ADDENDUM NO. 3

October 2, 2019

ST. CHARLES COUNTY

ROUTE 364 AT GUTERMUTH ROAD INTERCHANGE STP-7302(669) J6P3350

U.I.P. AND REHAB. EXISTING (64'-64'-64'-64'-64') PRESTRESSED CONCRETE I-GIRDER SPANS (SQUARE)

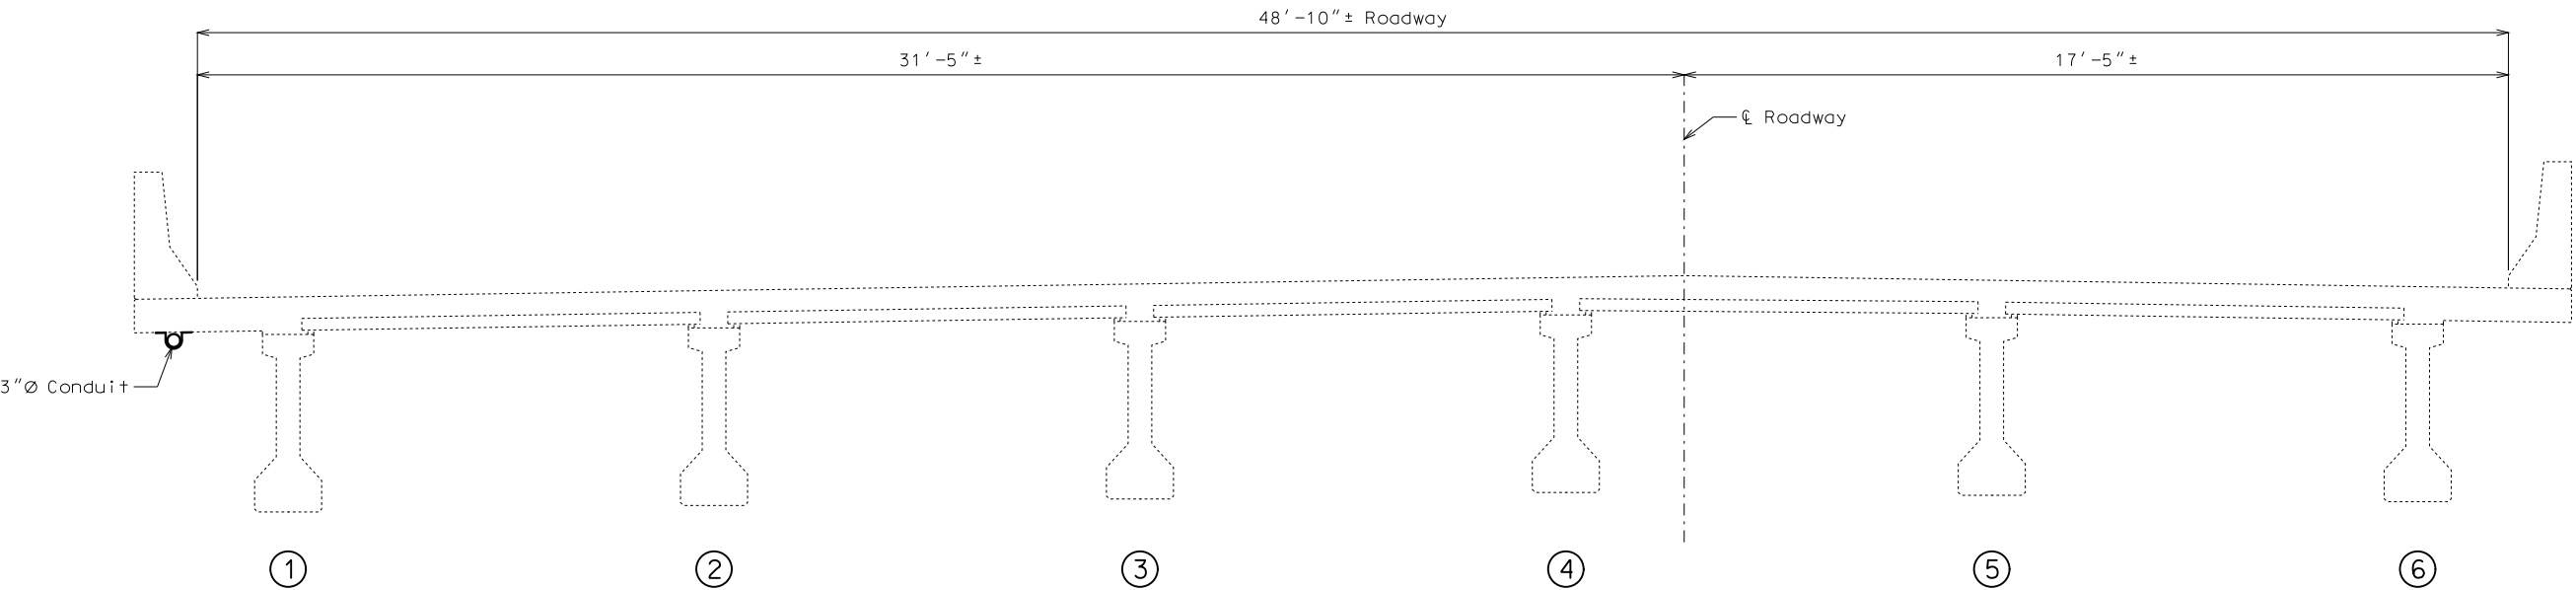
- Q. The State of Missouri requires the use of Aluminum Conduit on their bridges. The plans call for the installation of 2 each 3” conduits to be installed on the Gutermuth Bridge over Route 364. Why would we install 2 ea. 3” conduits on the bridge when this can be done by installing 1 ea 2” Conduit for running the two circuits (Circuit 3 and 4)?

- A. According to MoDOT’s Engineering Policy Guide Section 901.10.3, 3” conduit is required. The Contractor will only be required to install one of the 3” conduits on the existing Gutermuth Bridge over Route 364, which is why the bid quantity was adjusted above. Attached are two sample drawings provided by MoDOT’s Bridge Division for the conduit installation, which states the conduit shall be rigid nonmetallic schedule 40 heavy wall PVC.
